UNITED STATES PATENT AND TRADEMARK OFFICE

APPLICATION NO.	FILING DATE	FIRST NAMED INVENTOR	ATTORNEY DOCKET NO.	CONFIRMATION NO.
10/574,425	04/04/2006	Hans Lindh	P/1830-19	7893
2352 7590 12/28/2007 OSTROLENK FABER GERB & SOFFEN 1180 AVENUE OF THE AMERICAS NEW YORK, NY 100368403			EXAMINER CHIN, PAUL T	
			ART UNIT 3652	PAPER NUMBER
			MAIL DATE 12/28/2007	DELIVERY MODE PAPER

Office Action Summary	Application No.	Applicant(s)	
	10/574,425	LINDH, HANS	
	Examiner	Art Unit	
	PAUL T. CHIN	3652

DETAILED ACTION

Exhibit A

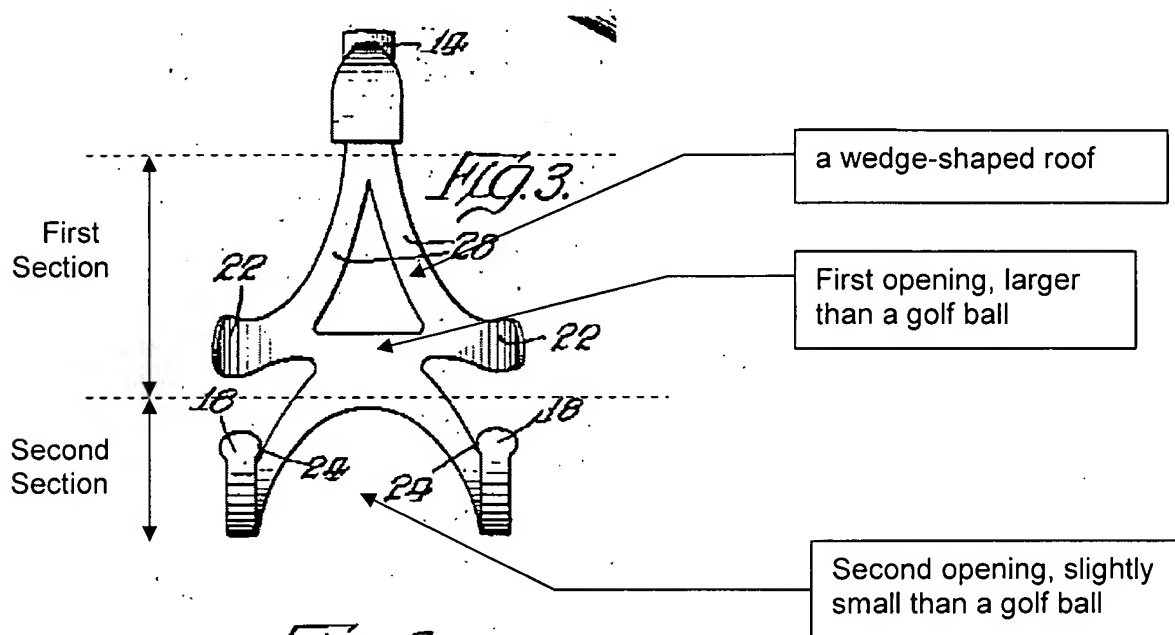
Zimmers (2,738,214) discloses a golf ball retrieval device (see Exhibits A,B) comprising an elongated handle (12,14), a cage having a rear end facing the elongated handle (12) and a front end facing away from the elongated handle (12), and a roof (see Figs. 2,3, and 4) extending from the rear end to the front end, a first section (22,22,28,28) located at the rear end of the cage, a second section (16,16) located at the front end wherein the first cage section has a first opening (see Fig. 3) and the second opening located the opposite of the rear end. Note that the spaced apart outwardly extending fingers (16,16)

and a roof (28) defines a first opening, which has a greater diameter than a golf ball, (see col. 2, lines 19-26) and the extending fingers (16,16) and a roof (28) defines a second opening (Figs. 1,2,3,8, and 10), which has a lesser diameter than a golf ball (see col. 2, lines 13-19). Exhibits A and B teaches a substantially wedge shape roof.

Also note that Zimmers's golf ball retrieving device is capable of free receiving a golf ball through the first opening (between the fingers 22,22) and retain the golf ball within the second opening to form a ball seating (18,18) wherein the second opening is capable of being enlarged if pressed by a user.

Exhibit B

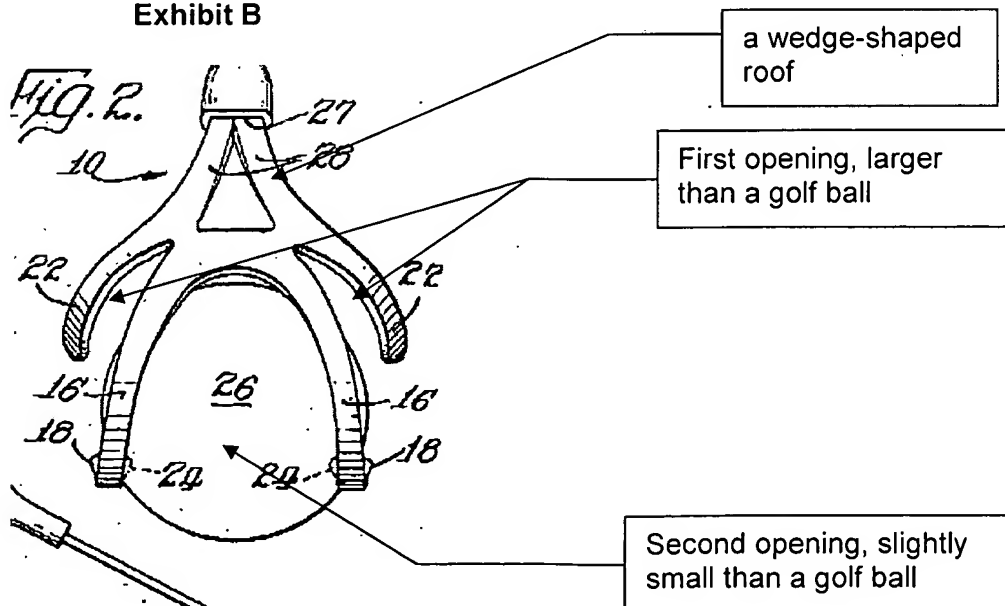
Re claim 3, Exhibit B substantially teaches a plane defined by an edge of the second opening defined an angle with respect to a longitudinal axis of the handle (12).

Exhibit C

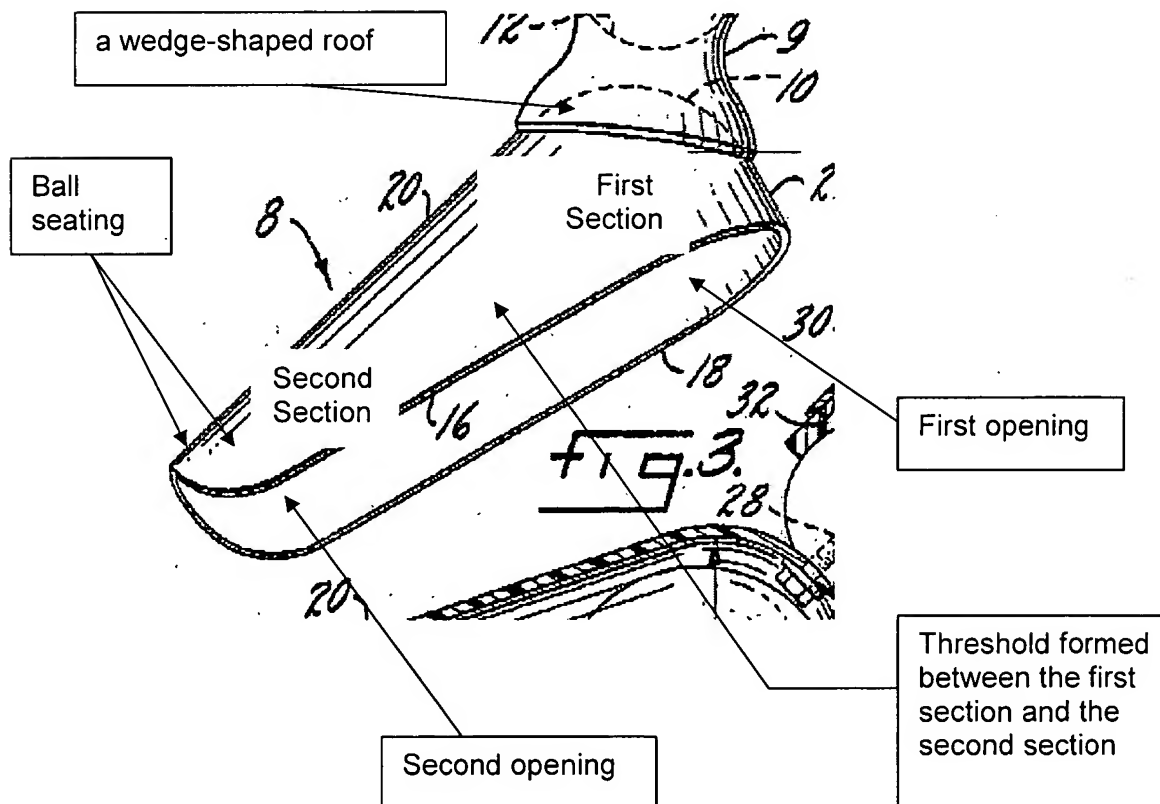
Jenkins (3,265,430) discloses a golf ball retrieval device comprising an elongated handle (13,15), a cage (see Exhibit C) having a rear end facing the elongated handle and a front end facing away from the elongated handle, and a roof (see Figs. 1-3) extending from the rear end to the front end, a first section (see Exhibit C) located at the rear end of the cage, a second section located at the front end wherein the first cage section has a first opening (see Exhibit C) and the second opening located the opposite of the rear end. Note that the spaced apart outwardly extending walls (16,18) and a roof (20) defines a

first opening, and the frontal extending walls (16,18) and a roof (20) defines a second opening as shown below. Jenkins's golf ball retrieval device (3,265,430) does not clearly teach the dimensional structure of the first and second openings to capture a golf ball. However, Jenkins's golf ball retrieval device (3,265,430) teaches that the upper portion of the opposed walls of the first opening is substantially smaller than the golf ball (col. 2, lines 3-8, and Fig. 3) and figures 4 and 5 also teach that the opposed and spaced apart walls (38,40) has a distance being smaller than a golf ball (col. 2, lines 22-47).

Re claim 2, Exhibit C shows a threshold formed between the first section and the second section to prevent the ball from rolling from the ball seating.

Re claims 3 and 5, Exhibit C teaches a plane defined by an edge of the second opening defined an angle with respect to the longitudinal axis of the handle.

Re claim 4, the ball seating (See Exhibit C) and the cage roof (20) are capable being positioned a center of gravity of the ball beneath the longitudinal axis of the elongated handle (15) because the distal end of the handle, a ball or sphere, is designed to be freely rotatable at a socket joint (12).
